Royalston Historic District Commission

Application for Certificate

PROVIDE 3-PHASE SERVICE TO TOWN HALL.

Subject: RE: EXT || Reminder re: Historic District Commission

POLES #7-#10.

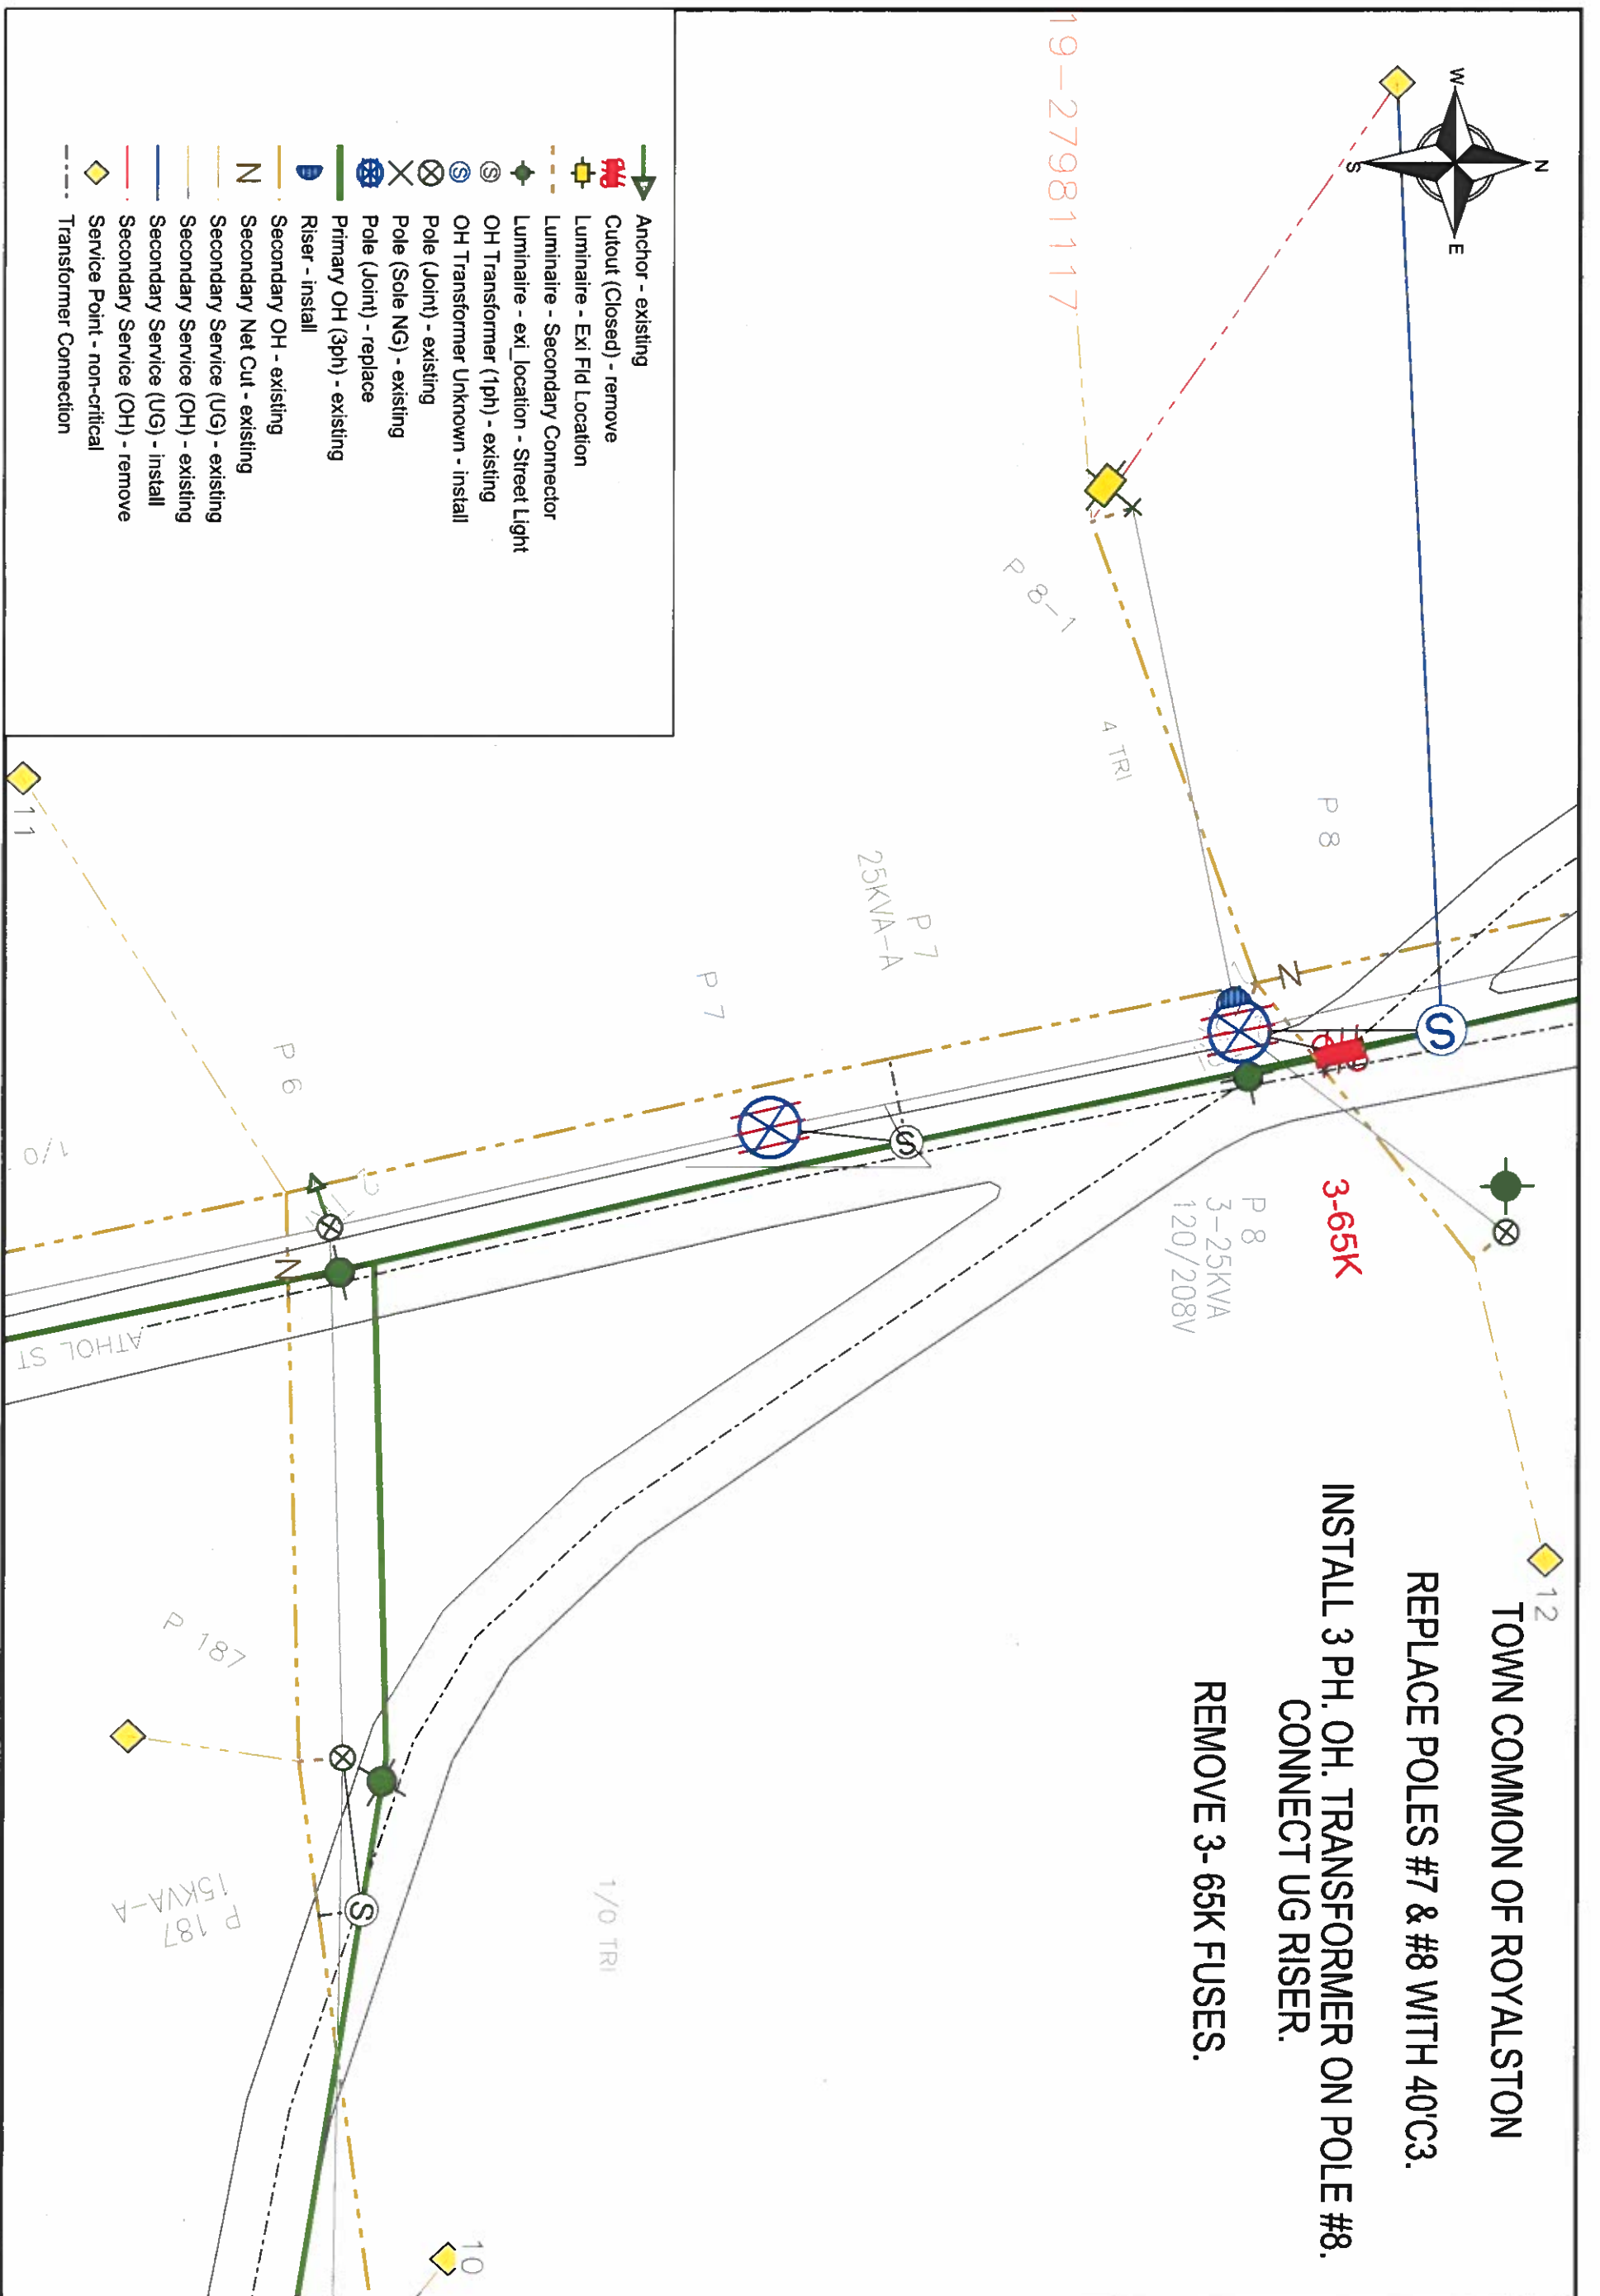
What you sent me still leaves some open questions:

- It looks like poles 7, 8 and 10 (but not 9) will be replaced. Not clear if pole 8-1 will be removed. *Pole 8-1 will not be removed. The service line running to it will be removed however.*
- What is the above ground height of a 40'C3 pole? *About 34'*
- What will happen to the light fixture currently on pole 8? *If National Grid owned, it will be transferred over. If town owned, the town will likely have to transfer it.*
